SAFETY ALERT

Trim Tab Reinforcement

SA-LTUL-CTSW-03

Technical Advice No.13 – revision 1

Fig B1 & B2: Reinforcement installed to the trim tab
(Tab shown bottom surface facing up)

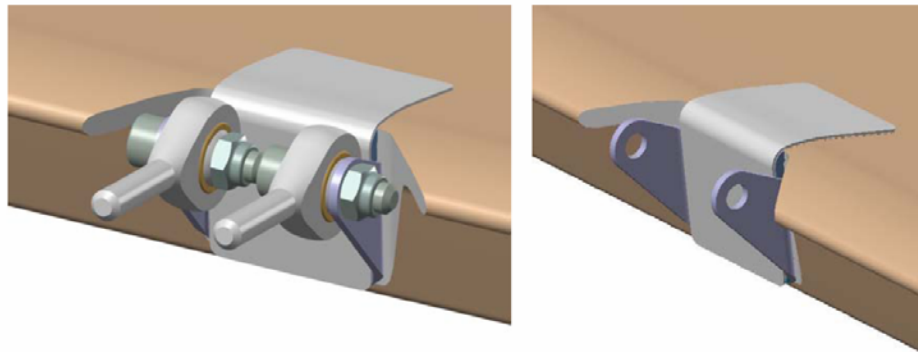
The investigation did determine that a pitch control vibration could result from the upper and lower trim tab (anti servo tab) skin exactly in the area of the Trim Tab Bracket (Part No. KA 3011110) as evidenced by a crack located at the attachment point. (Fig. A)

If cracks are found in the area of bonding (attach point) (Fig. A), the aircraft must not be flown until the mandated reinforcement procedure is completed.

The reinforcement procedure consists of reinforcing the point at which the control horn is bonded to the trim tab by the addition of specifically designed part manufactured by Flight Design (WA 3011011). The part is glued (bonded) to the control rod bracket and the lower trim tab surface and delivers a secondary load path for the trim tab control forces. The modification can be done without removing the trim tab, and does not require painting action. (Figs.B1 & B2)

The procedure shall be completed according to Flight Design document: "070625 – TRIM TAB REINFORCEMENT PROCEDURE" that accompanies this Safety Directive, and supplemented by the Maintenance Manual.
